ADDENDUM #2 February 24, 2016

**McEniry Building Chiller Replacement
University of North Carolina at Charlotte
9201 University City Blvd.
Charlotte, North Carolina 28223**

The following Addendum clarifies, revises, and takes precedence over Drawings and Specifications dated December 11, 2015. This addendum shall become a part of the Contract Documents for the above-mentioned. The following items are intended to revise and clarify the Drawings and Specifications and shall be included by the bidder in his proposal.

| SHEET | M101 |

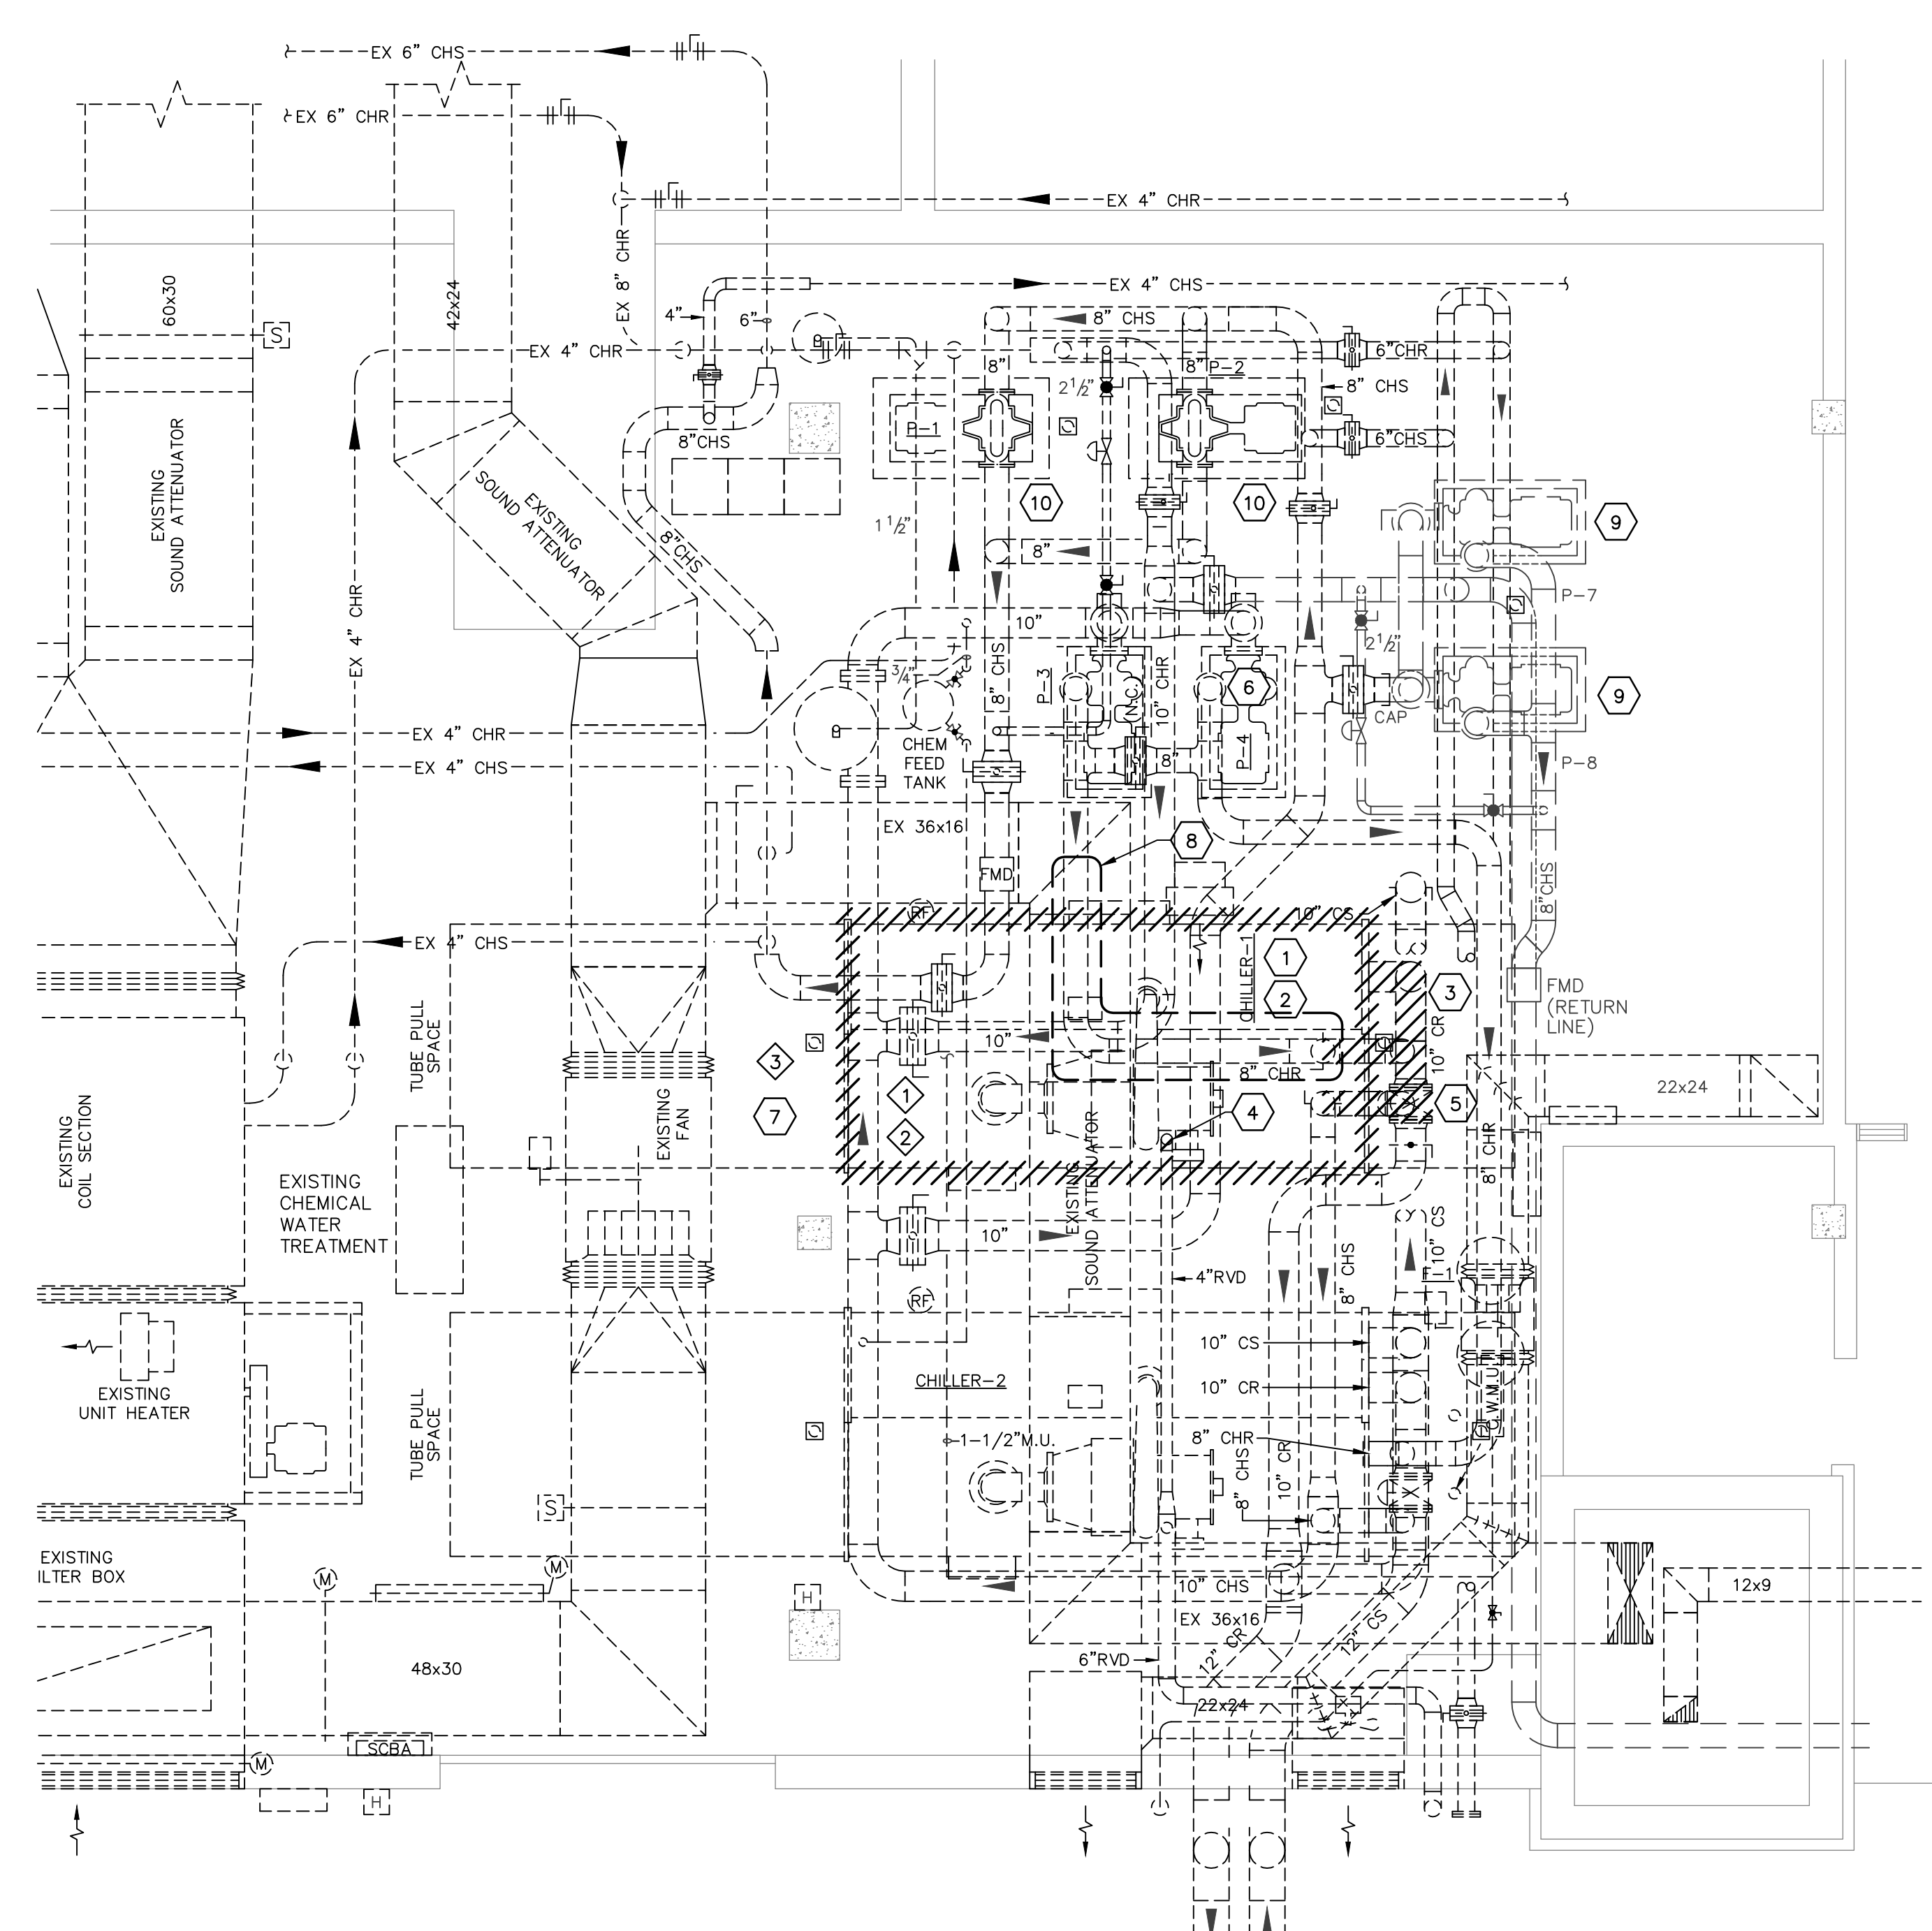
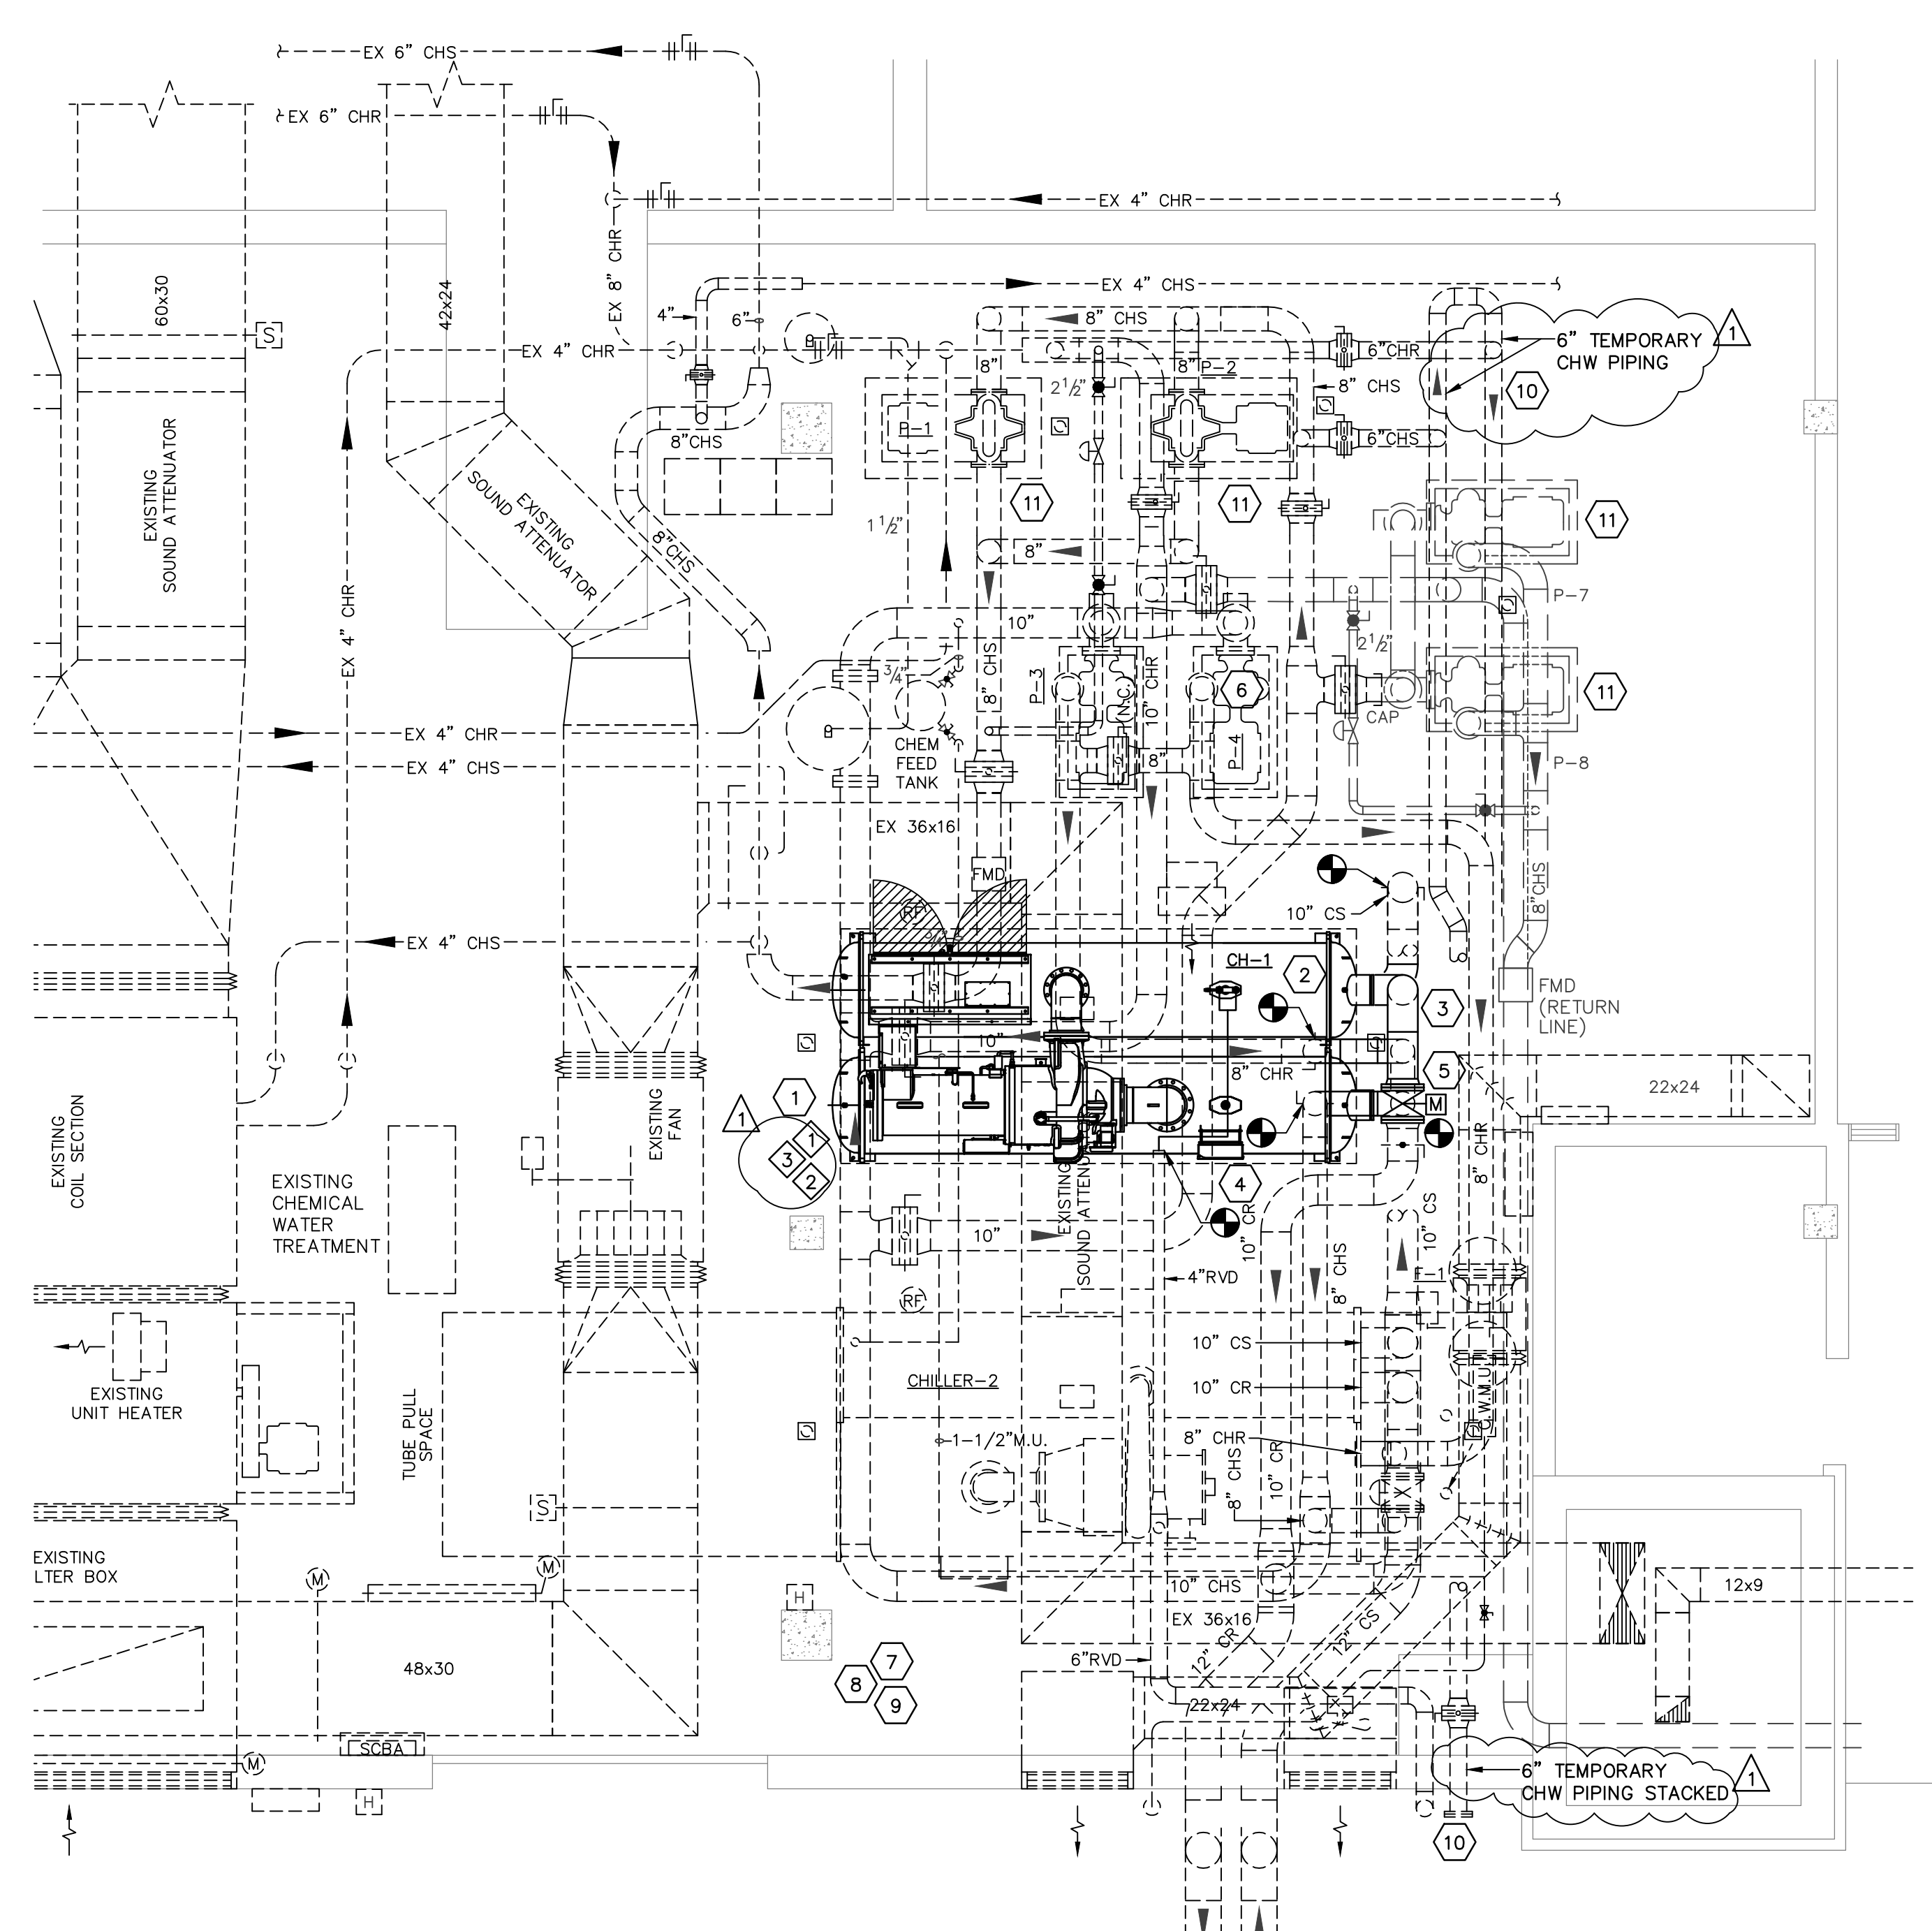
- A. Keynote #8 clarified to include replacement of pneumatic actuators with DDC actuators and not replacement of entire valve.
- B. Controls alternates clarified.
- C. Extent of temporary chilled water piping to be replaced clarified.
- D. Electrical keynote #3 added.

- REPLACE ALL EXISTING PNEUMATIC ACTUATORS ON CONTROLS VALVES IN MECHANICAL ROOM AND COOLING TOWER YARD WITH NEW, MOTORIZED DDC CONTROL ACTUATORS. AT A MINIMUM, THIS IS TO INCLUDE THE CONDENSER WATER SHUTOFF VALVES, SECONDARY CHILLED WATER PRESSURE RELIEF VALVE, 3-WAY CONDENSER WATER BYPASS VALVE, AND AHU CONTROL VALVE. TIE INTO BUILDING AUTOMATION SYSTEM.
- ALTERNATE #4:** UPGRADE ALL CHILLED WATER DIFFERENTIAL PRESSURE SENSORS IN EXISTING CHILLED WATER SYSTEM. NEW SENSORS SHALL BE SCHNEIDER EPW2104-LCD, 0-100PSI, 0-24VDC WITH LOCAL LCD DISPLAYS OR EQUAL.
- ALTERNATE #5:** REPLACE ALL EXISTING 6" TEMPORARY CHILLER CONNECTION PIPING BETWEEN ISOLATION VALVES NEAR EXISTING PUMP P-2 AND EXTERIOR OF BUILDING, WITH NEW 8" PIPING.
- ALTERNATE #3:** INSTALL NEW DDC CONTROLS FOR VFDs CONTROLLING EXISTING PUMPS P-1, P-2, P-7, & P-8. TIE INTO BUILDING AUTOMATION SYSTEM.
